JAMES A. FITZPATRICK NUCLEAR POWER PLANT

AMENDMENT TO FACILITY OPERATING LICENSE

Amendment No. 64
License No. DPR-59

SUPPORTING AMENDMENT NO. 64 TO FACILITY OPERATING LICENSE NO. DPR-59

Figure 3.5-9

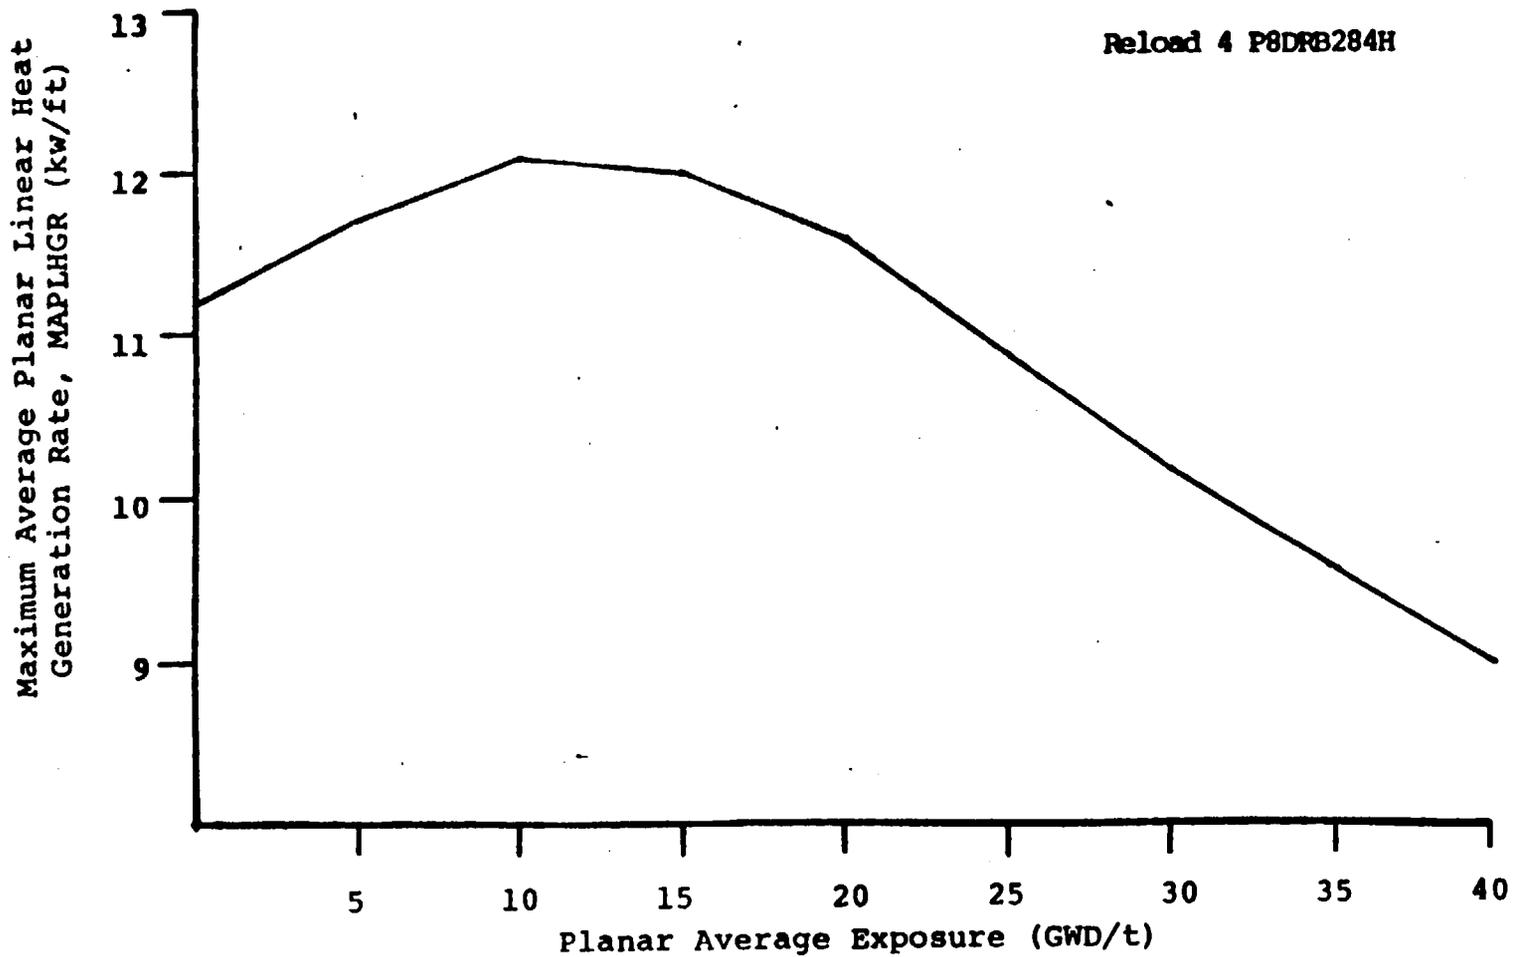
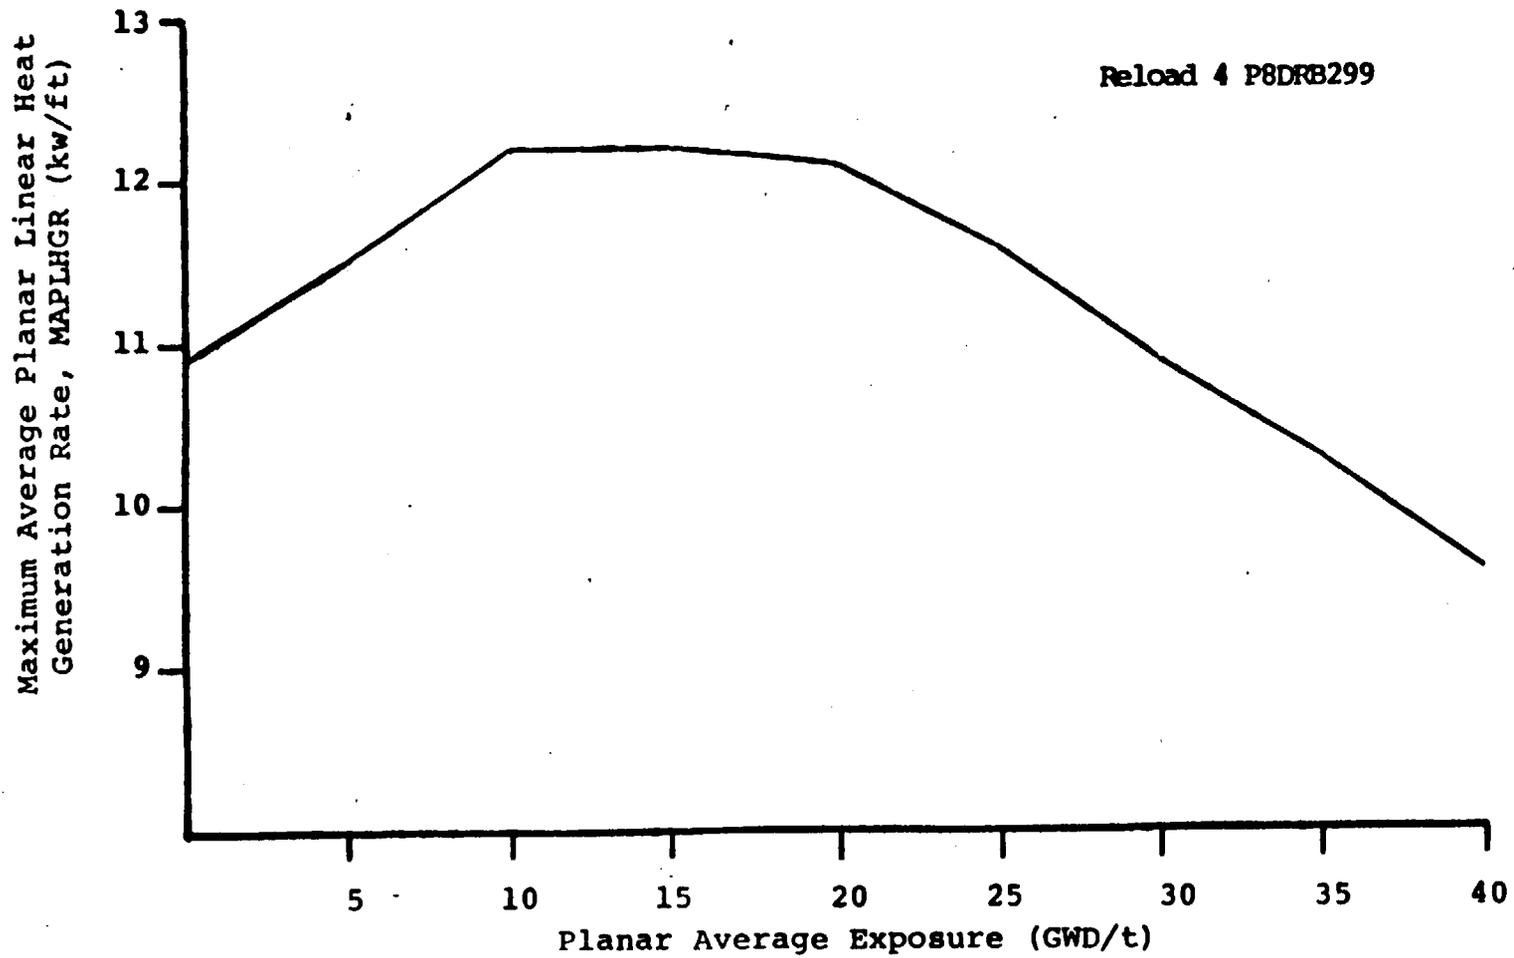
The APLHGR for each type of fuel as a function of average planar exposure shall not exceed the limiting value shown in Figures 3.5.3 through 3.5.10. If anytime during reactor power operation greater than 25% of rated power it is determined that the limiting value for APLHGR is being exceeded, action shall then be initiated within 15 minutes to restore operation to within the prescribed limits. If the APLHGR is not returned to within the prescribed limits within two (2) hours, an orderly reactor power reduction shall be commenced immediately. The reactor power shall be reduced to less than 25% of rated power within the next four hours, or until the APLHGR is returned to within the prescribed limits.

In References 7 and 8 GE requested that credit for calculated peak cladding temperature margin as well as credit for recently approved, but unapplied, ECCS evaluation model changes be used to offset any operating penalties due to high burnup fission gas release. This proposal was found acceptable (Ref. 9), provided the generic analysis was found to be applicable to each plant citing the GE position. In Attachment II of Reference 1 the licensee stated that the generic analysis is applicable to the FitzPatrick reload. On this basis we find the proposed Technical Specification changes (MAPLHGR limits) given in Attachment II of Reference 1 acceptable.
